ADDENDUM NO. CC-1

RAYMOND CENTRAL PUBLIC SCHOOLS  
RAYMOND CENTRAL JR. & SR. HIGH SCHOOL ADDITION  
RAYMOND, NEBRASKA  
DLR GROUP PROJECT NO. 10-16113-00

COMBINED CONTRACT

August 12, 2016

53 JAMB  
A9.1 SCALE: 1 1/2" = 1'-0"

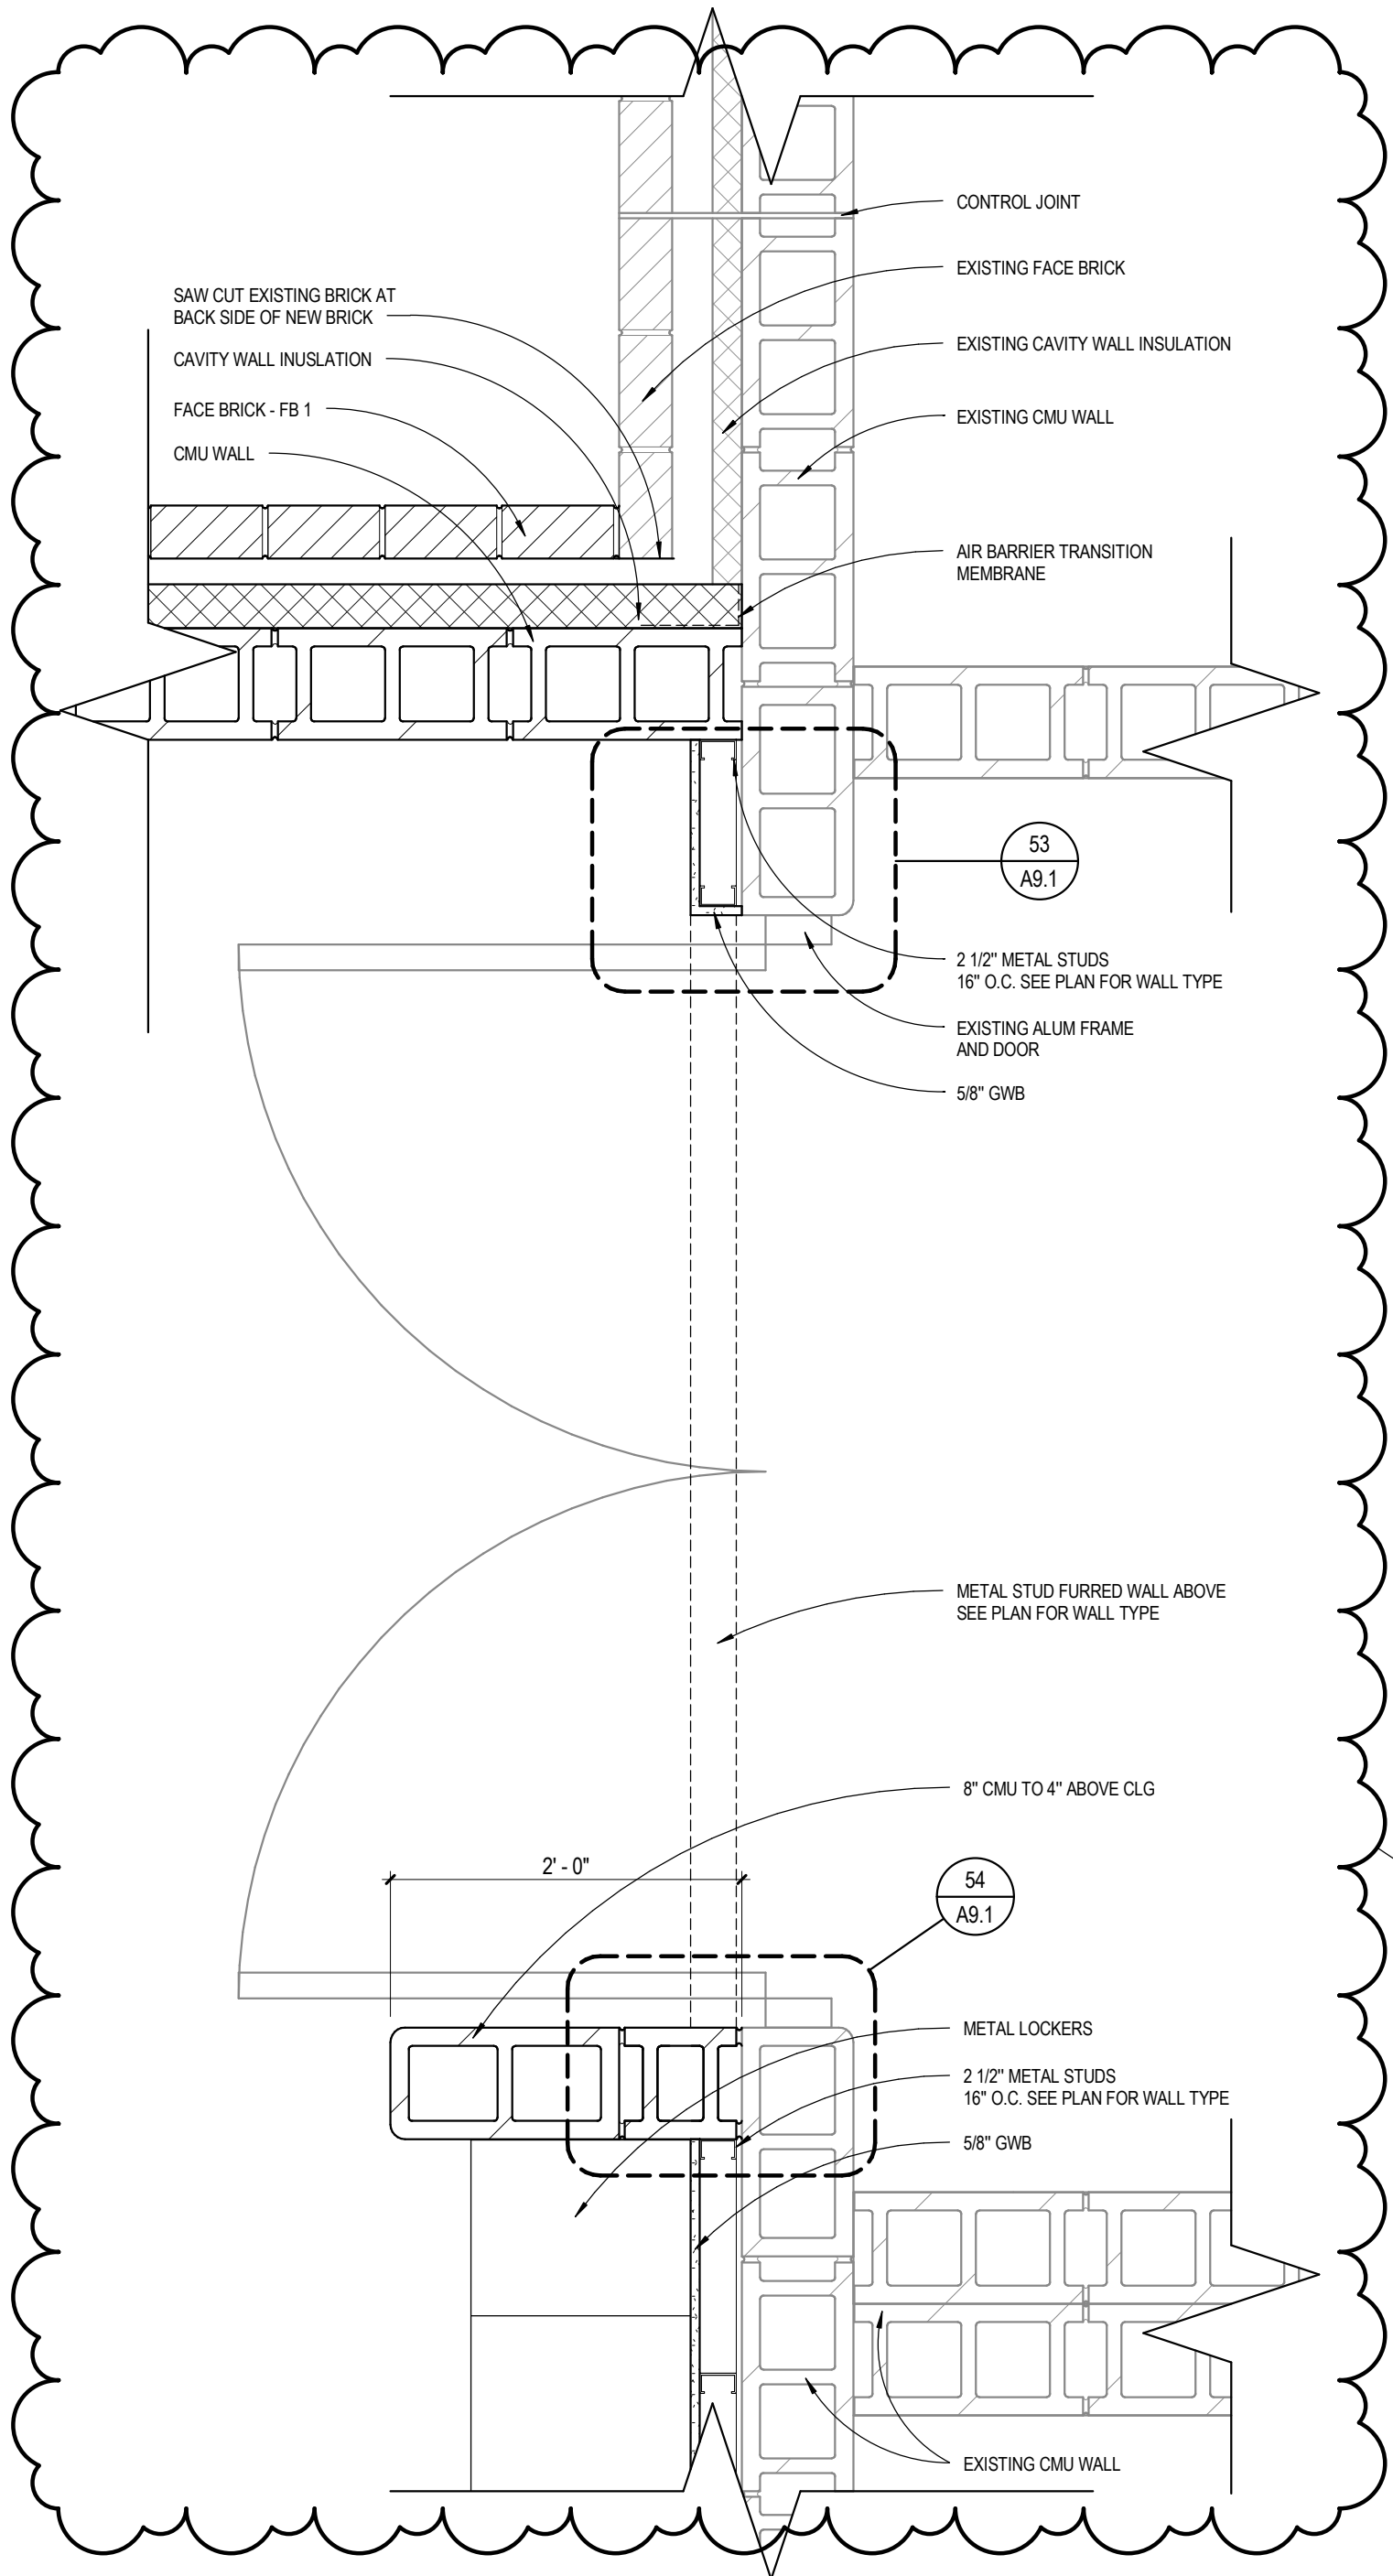
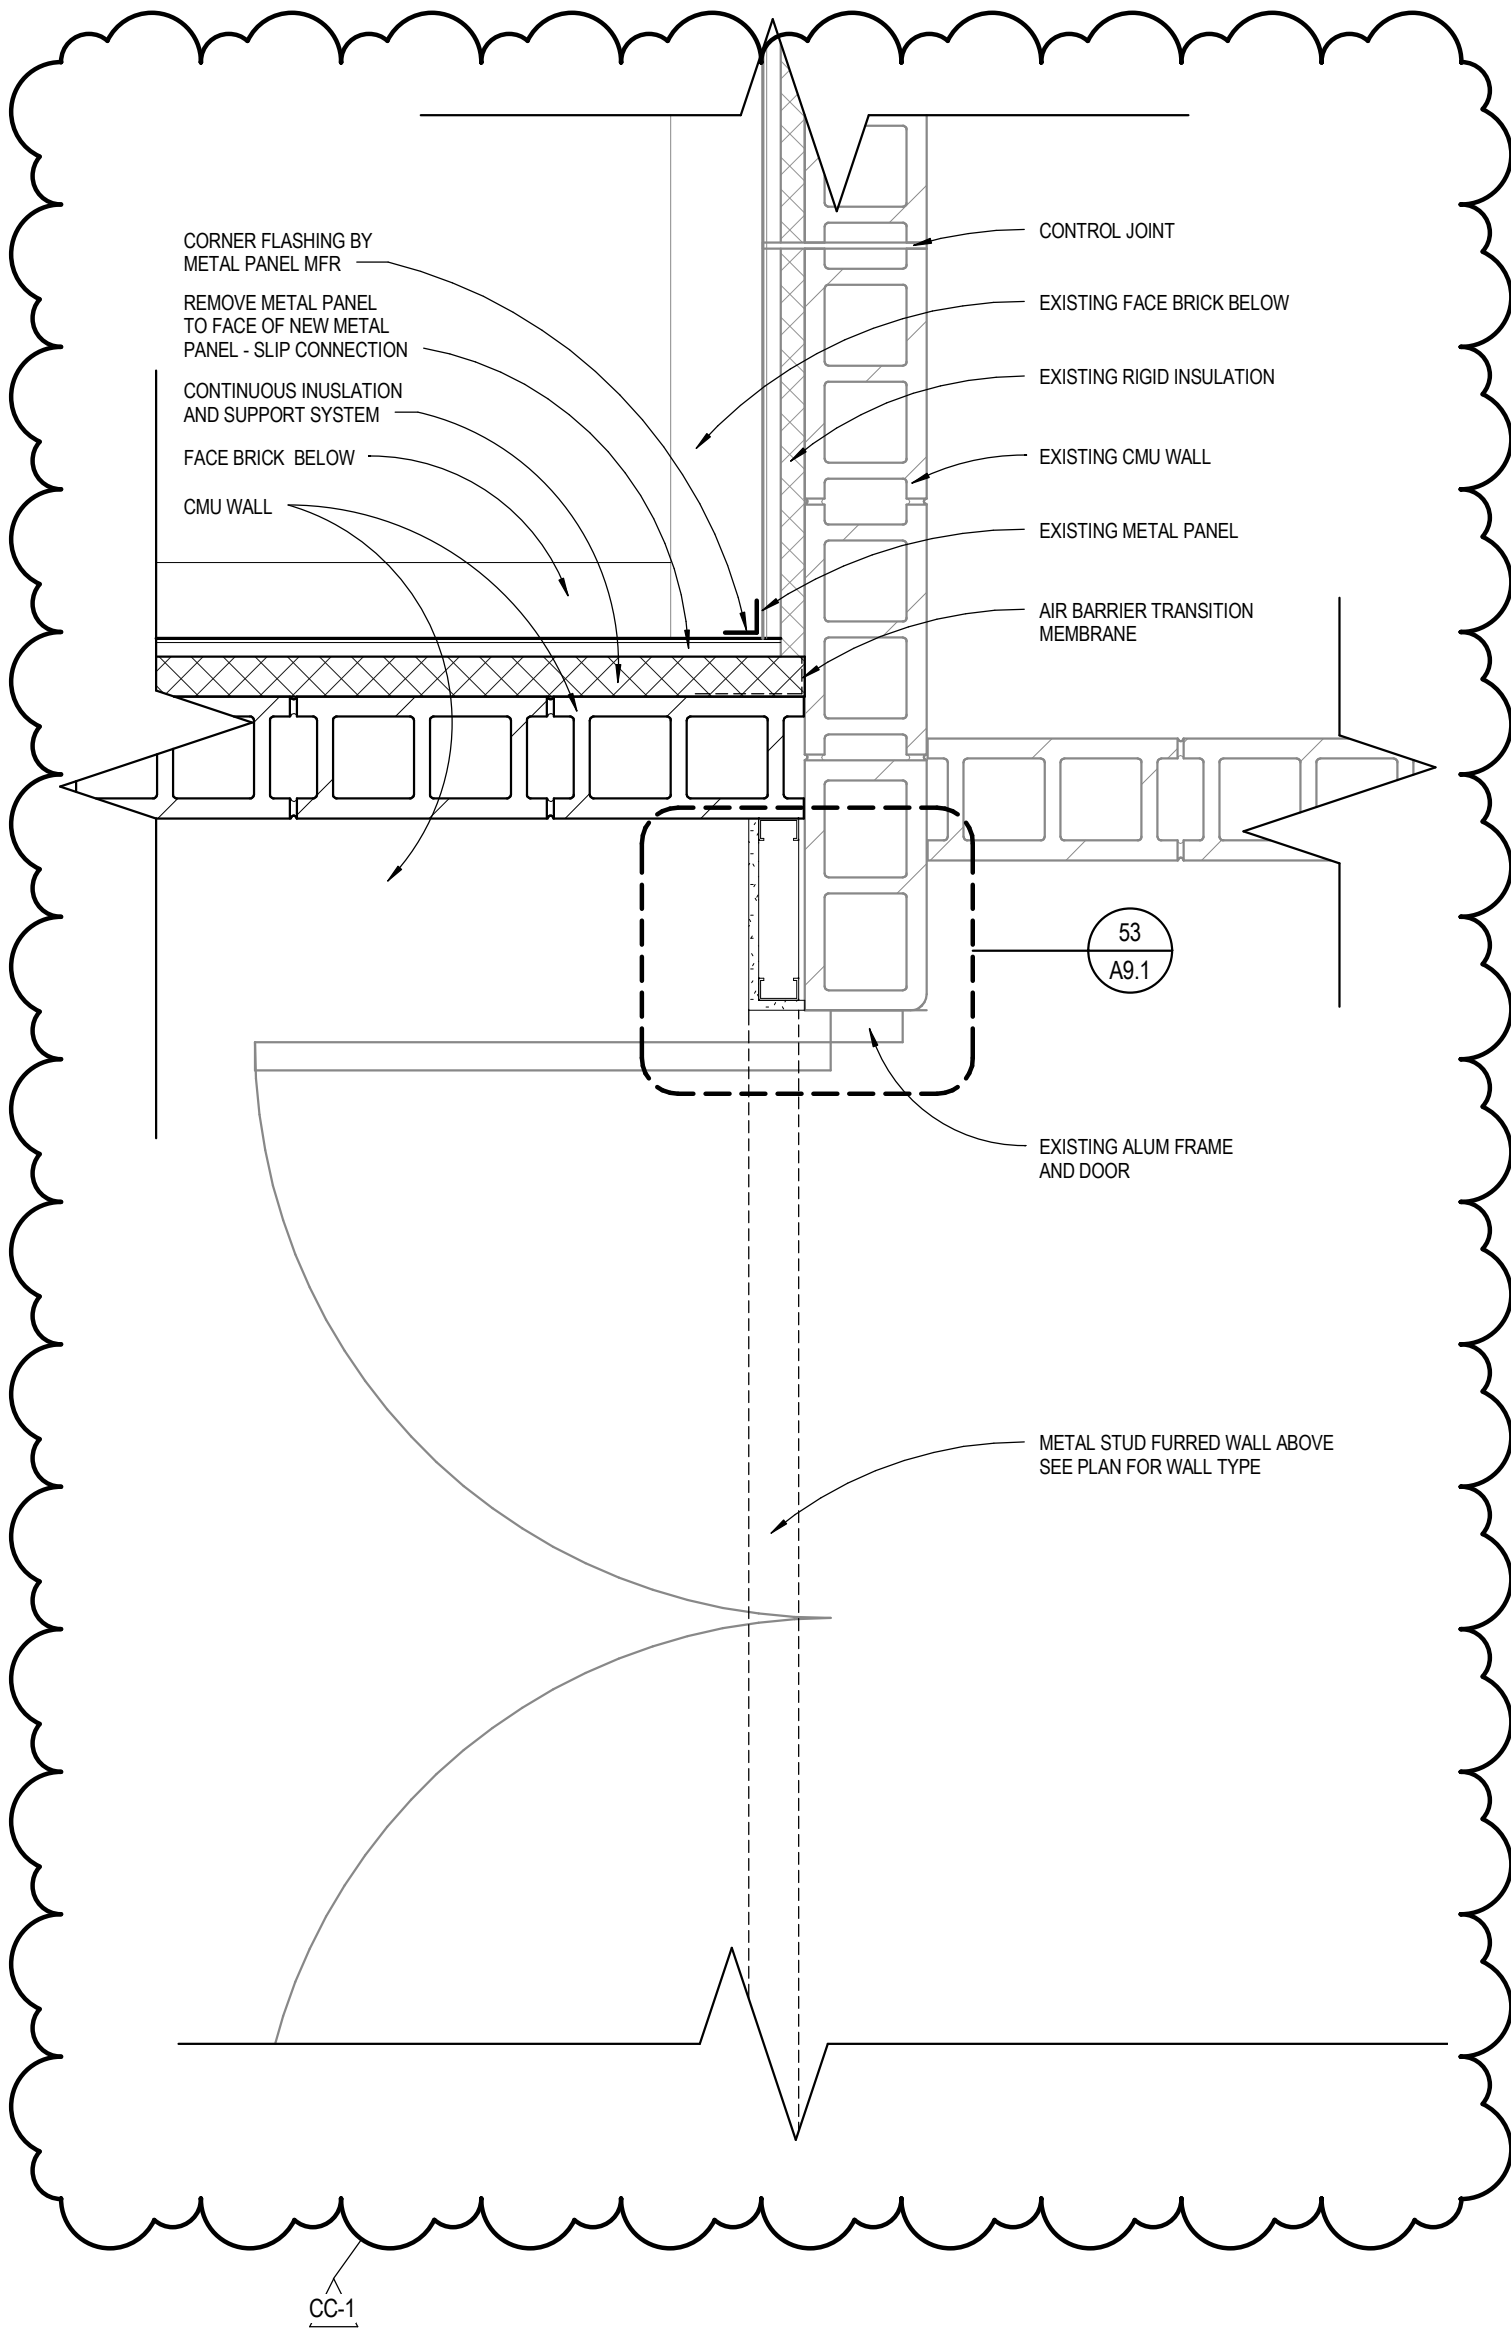
ITEM NO. 8 DRAWING A9.1 DOOR AND FRAME SCHEDULE

- A. Detail 53/A9.1 Delete in its entirety and substitute new Detail 53/A9.1 as shown on Attachment A9.1-1.

FINISH FLOOR PLAN, FIRST LEVEL - AREA A  
RAYMOND CENTRAL JR. & SR. HIGH SCHOOL  
ADDITION

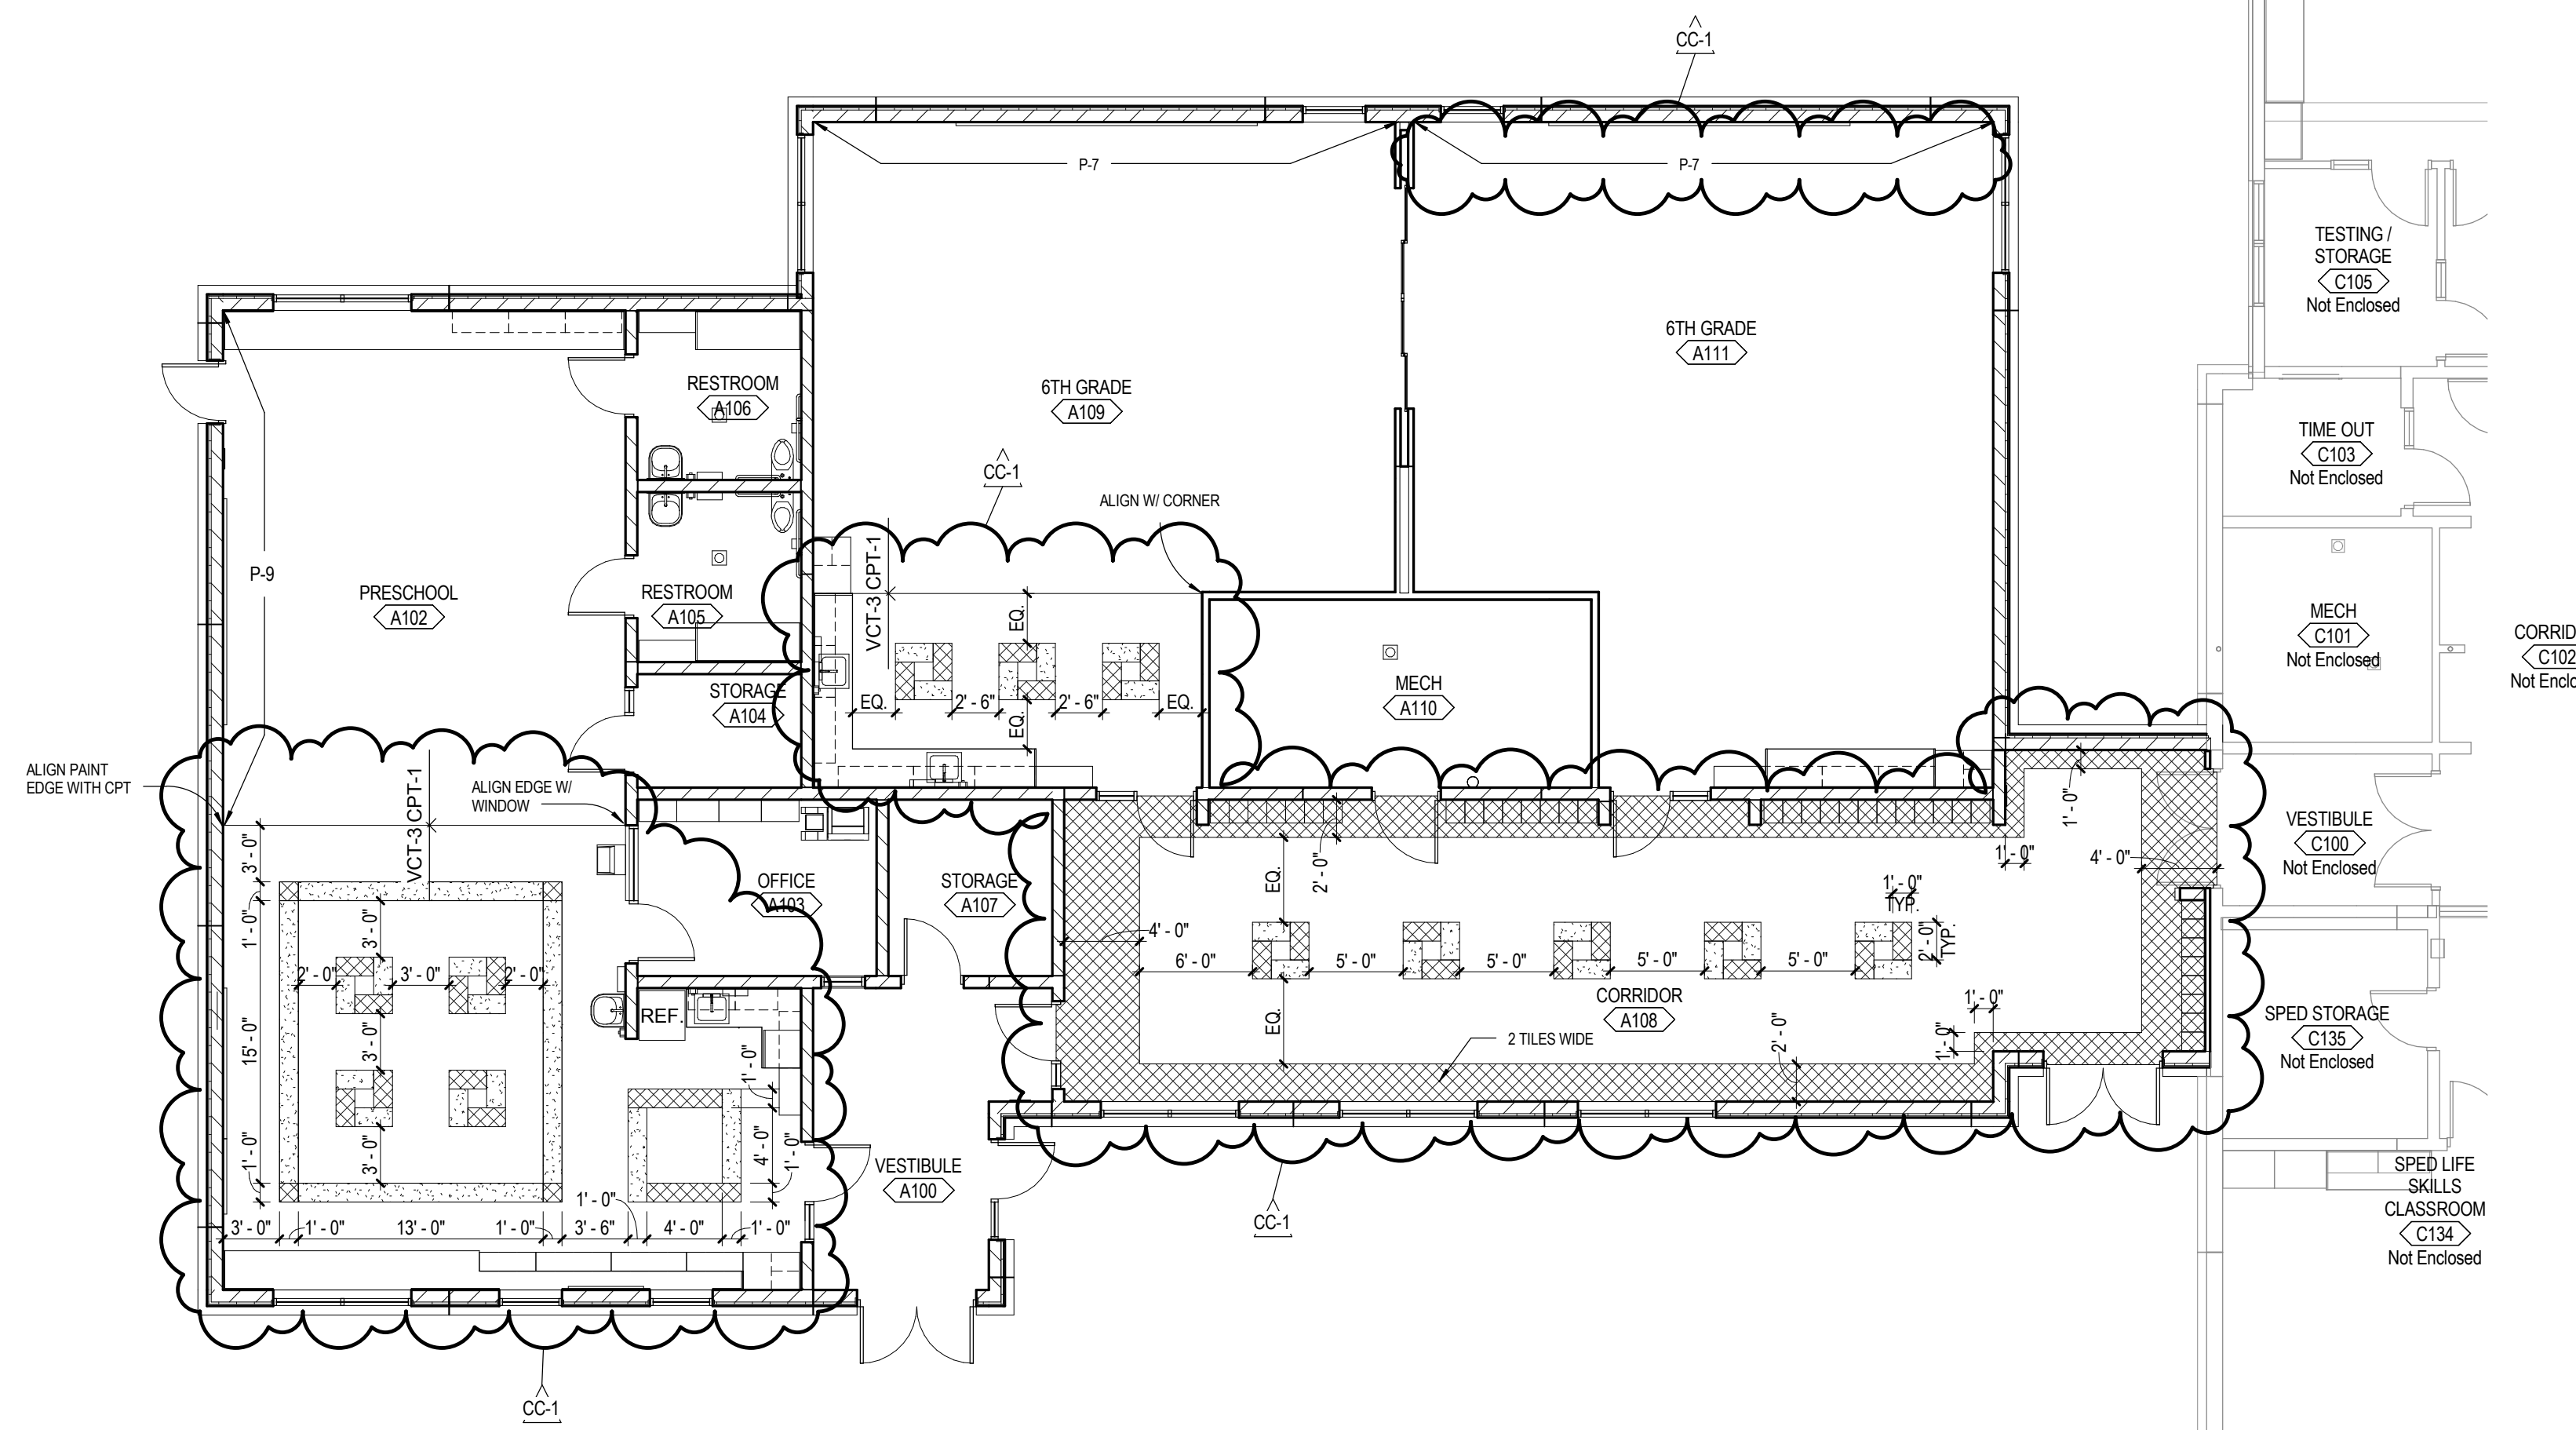
ITEM NO. 10 DRAWING A13.1 FINISH FLOOR PLAN, FIRST LEVEL – AREA A

- A. Delete Drawing in its entirety and substitute new Drawing A13.1 as shown on Attachment A13.1-1.
